Office Action Summary

09/455,991

OHTANI ET AL.

DETAILED ACTION

FIG. 8
(Prior Art)

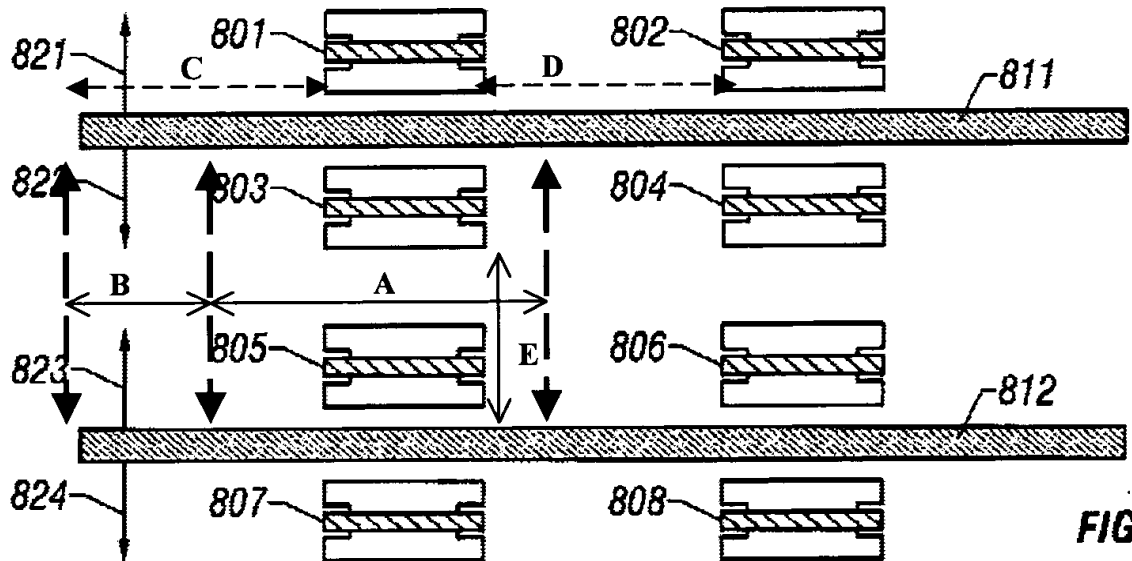
Regarding claims 6, 9, 23, 31, 39, 55, and 63, Applicant acknowledges a well-known method comprising the steps of: forming an amorphous semiconductor film (see page 1, lines 24-26) on a substrate (see page 1, lines 11-13); providing a metal element (811, 812) capable of promoting crystallization of the amorphous

semiconductor film to form a first metal element added region (811) and a second metal element added region (812) (see fig. 8, below); crystallizing the amorphous semiconductor film so that a crystal growth (822, 823) proceeds in a crystal growth direction parallel to the insulating surface to form first and second crystalline portion (see regions A and B between the metal element 811 and 812 in Fig. 8, below); patterning the crystalline semiconductor film to form at least one crystalline island or active region (803) using only the first crystalline portion (see region A between the metal element 811 and 812 in Fig. 8, below); wherein the first metal element added region (811) is away from the second metal element added region (812); wherein carrier move in the crystalline semiconductor island (803) in a carrier moving direction identical with the crystal growth direction (822, 823) (see page 4, lines 9-11 and fig. 8, below); wherein the second metal element added region (812) is located apart from the crystalline semiconductor island (803) by a distance (E) (see Fig. 8, below); wherein the first metal element added region (811) has a length extending longer from an end portion of the crystalline semiconductor island (803) in a longitudinal direction of the first metal element added region (consider the portion of the metal element (811) that is between the end side of the region (B) and the end side of the crystalline semiconductor island (803) in Fig. 8, below).

With regards to the "dummy metal regions", it is noted that nowhere in the claims Applicant recites such "dummy metal regions." As a matter of fact, Applicant only claims the formation of "a first metal element added region" and "a second metal element added region", which both are taught in figure 8 of Applicant's admitted prior art as regions 811 and 812.

With regards to the limitations about the length of 50% or more of a crystal growth distance, and the length of about 100 μm or more, please note that figure 8

discloses that the metal added regions (811, 812) are further extended from an end portion of the crystalline semiconductor islands (803-806), which appear to have the same length dimension than the extended portion of the "dummy metal regions" 701/702 of figure 7. Thus, the claimed length range is merely an optimization of the teaching provided by figure 8. Therefore, it would have been obvious to one of ordinary skill in the art, since it has been held that where the general conditions of a claim are disclosed in the prior art, discovering the optimum or working ranges involves only routine skill in the art. *In re Huang*, 40 USPQ2d 1685,1688(Fed. Cir. 1996) citing *In re Aller*, 105 USPQ 233., 235 (CCPA 1955).
